The Town of Hilton Head Island
Design Review Board Regular Meeting
Tuesday, May 28, 2019 – 1:15 p.m.
Benjamin M. Racusin Council Chambers
AGENDA

PROJECT NAME: Heffner Pergola

DRB#: DRB-001107-2019

PROJECT NAME: Nunzio Restaurant

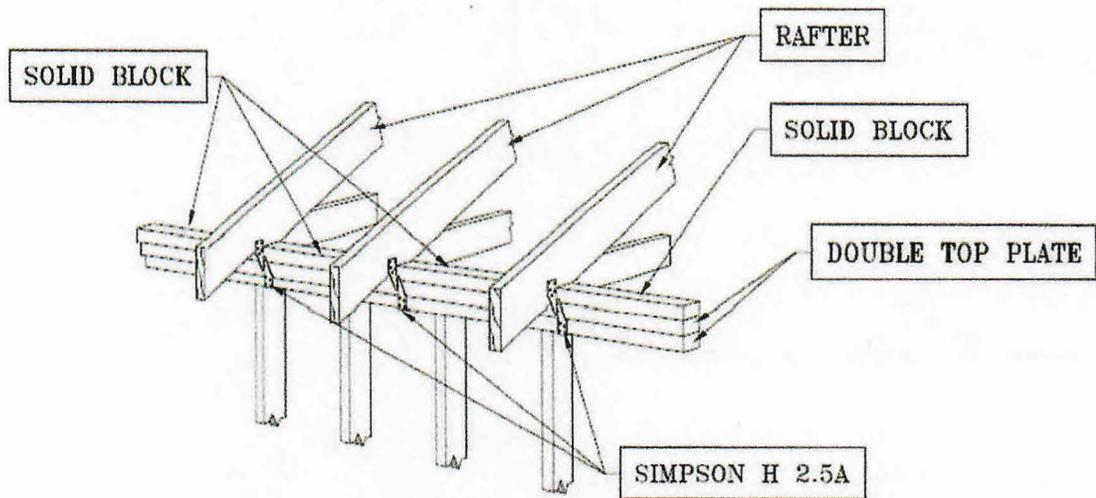
The picture below is of the canopy. The post to the left in the picture is in the middle of the canopy on the southeastern wall. This post needs to be bolted to the concrete block wall with $\frac{1}{2}$ " red head bolts with a minimum penetration into the block wall of 5". The red head is to be epoxied into place with Simpson 2-part epoxy or equal. Place 3 bolts @ 18" o.c. in the wood post.

The post to the right in the picture above is closest to the exterior of the deck and it too, needs to be bolted to the concrete block wall with $\frac{1}{2}$ " red head bolts with a minimum penetration into the block wall of 5". The red head is to be epoxied into place with Simpson 2-part epoxy or equal. Place 3 bolts @ 18" o.c. in the wood post.

Sheet No. **A2.0**

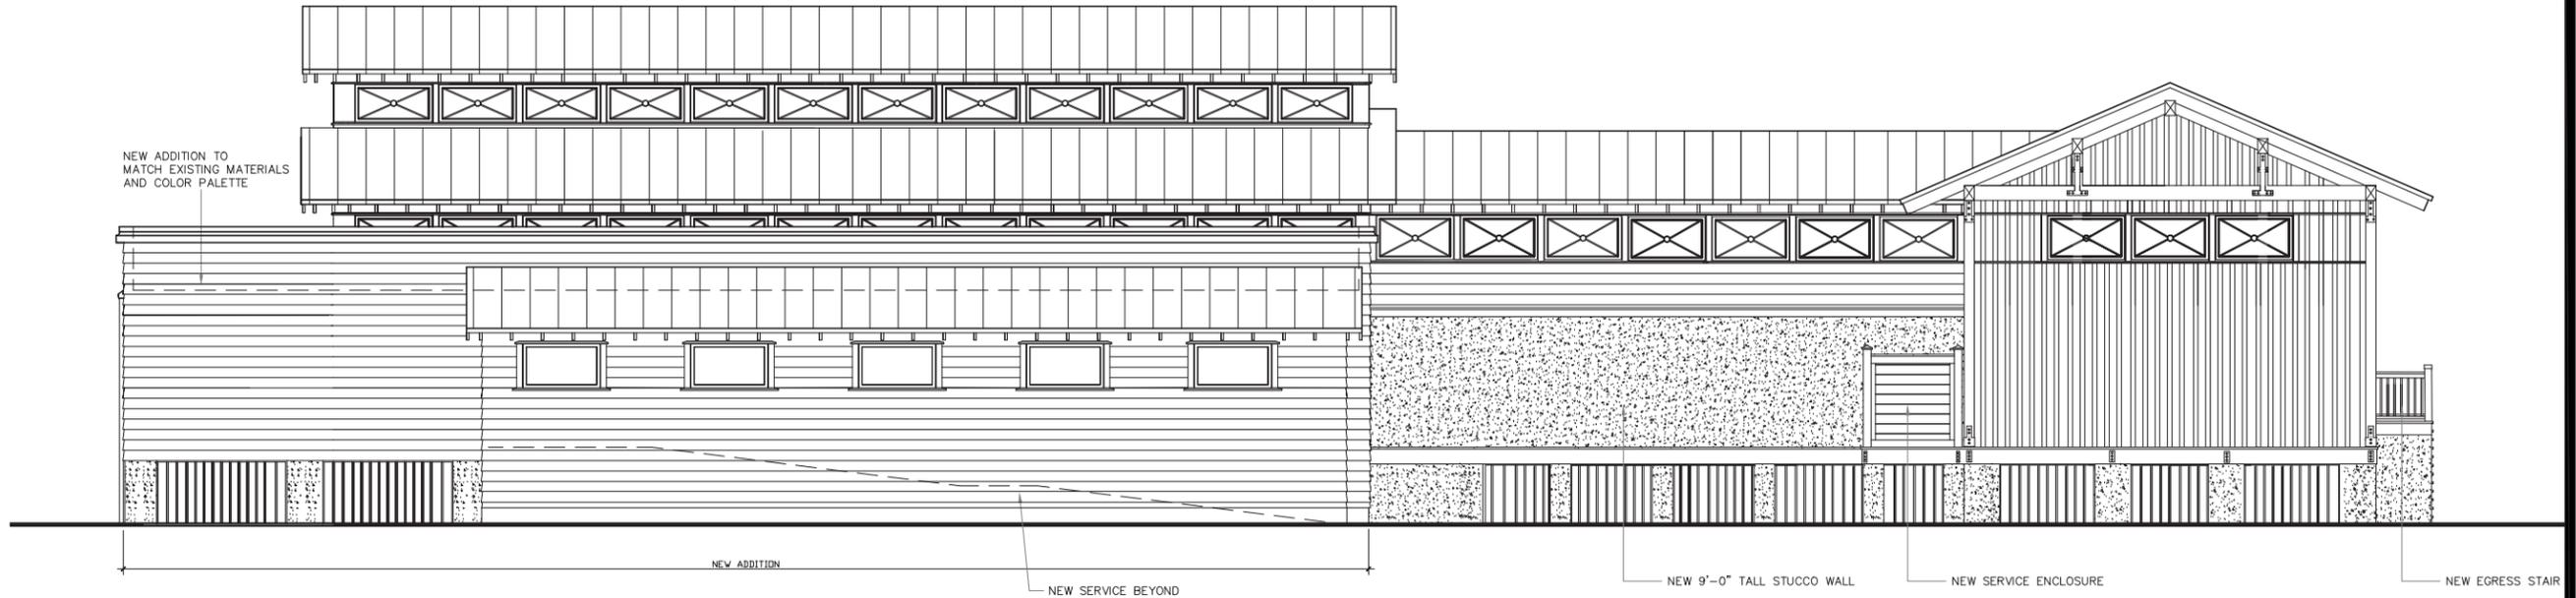
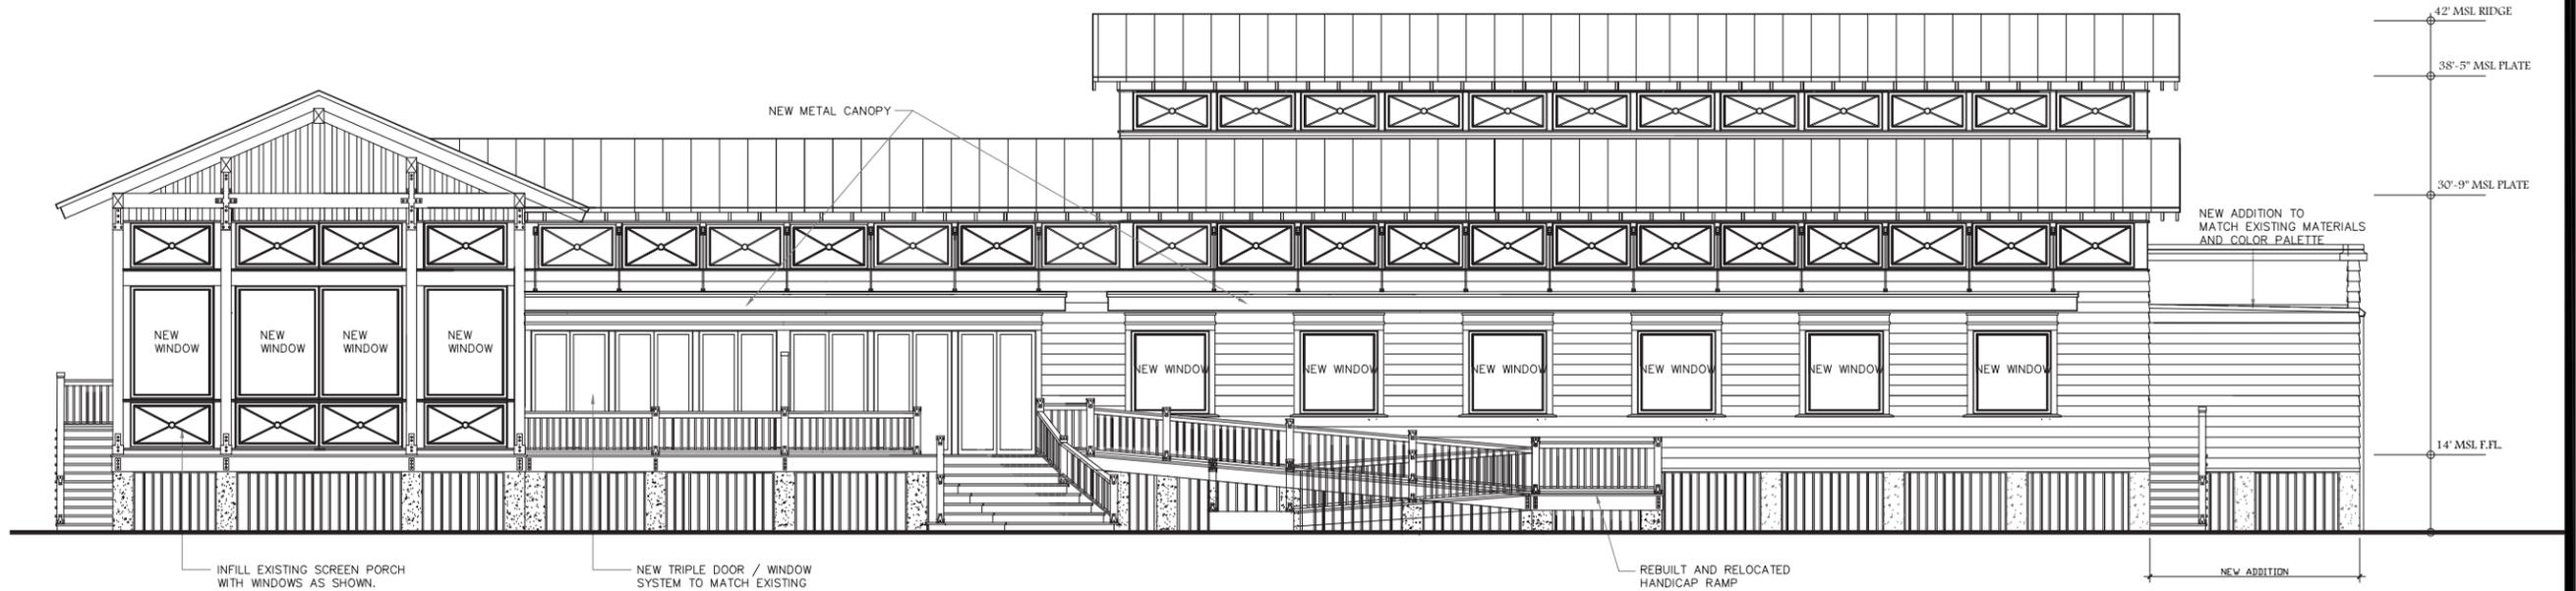
Reduce the foot-candle or brightness of the light source at the top of the front gable and change the light color or temperature to match the balance of the building.

DESIGN GUIDE/LMO CRITERIA	Complies Yes	No	Not Applicable	Comments or Conditions
Decorative lighting is limited and low wattage and adds to the visual character	<input type="checkbox"/>	<input checked="" type="checkbox"/>	<input type="checkbox"/>	The light on the front gable end is too bright, creates a hotspot and spears to be a different color. Reduce the foot-candles and change the light source to match the balance of the exterior lighting.
